DATE: December 9, 2011
TO: Jim Abrams, Gibson Dunn & Crutcher, LLP
FROM: Sarah Jones, Planning Department
RE: PPA Case No. 2011.1122U for 75 Howard Street

Preliminary Project Assessment

Date: December 9, 2011
Case No.: **2011.1122U**
Project Address: 75 Howard Street
Block/Lot: 3741/031
Zoning: C-3-O(SD) – Downtown Office (Special Development)
200-S
Project Sponsor: Jim Abrams, Gibson Dunn & Crutcher, LLP
(415) 393-8370
Staff Contact: Brett Bollinger – (415) 575-9024
brett.bollinger@sfgov.org

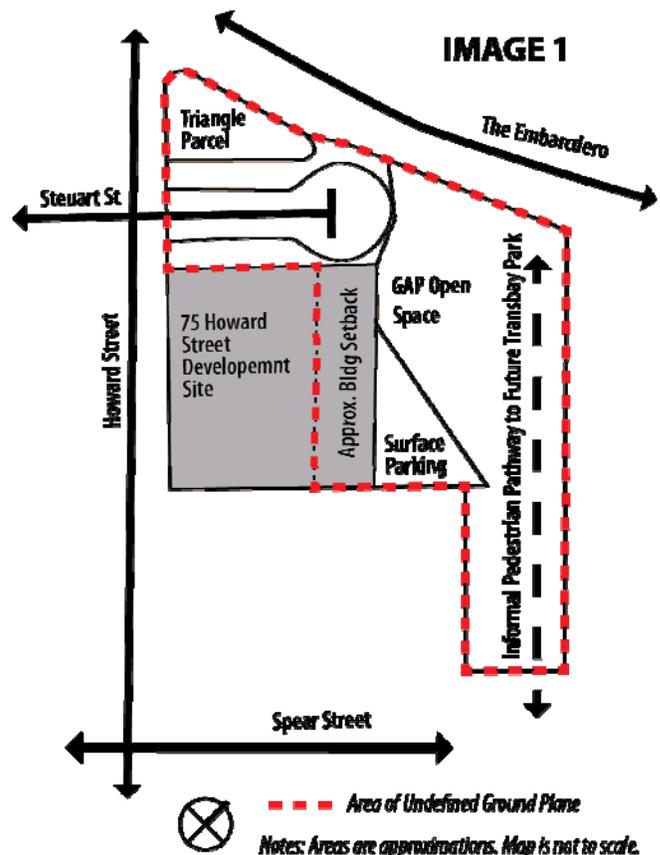
1. *Massing*: The predominant urban form along Steuart Street and the Embarcadero is an approximately 85'-100' high street wall, with towers, where they exist, set back from this base. Furthermore, the massing of towers has a strong pattern of stepping down to the waterfront. Moreover, as designed, the proposed height and bulk of this building will contribute to the shading of publicly accessible open space. Therefore, the Planning Department recommends that the building be massed to respect these conditions, by setting the tower back at least 38' from the Steuart Street façade, and 20' along

the southern side above a base that reinforces the existing context. The opportunity to better define the streets and open space using the flatiron site across Steuart Street should be explored.

2. *Architectural Character:* The overall articulation and modulation of the building design are successful. The Planning Department supports the general composition of the facades with a rhythm of vertically-articulated modules, and alterations to the glazing patterns. The Planning Department would like to see the recesses between the vertical modules to be more substantial and continuous.

3. *Public Realm:* The Planning Department expects a concerted effort to improve and unify the publicly accessible open spaces with neighboring properties and the end of Steuart Street. This should be further developed in the proposal. Additionally, because the project will be subject to the Better Streets Plan, it will be obligated to make improvements to the public realm on Howard and Steuart Streets. The intent of providing ground level open space to connect the informal paseo network is, while admirable, somewhat redundant, and not recommended.
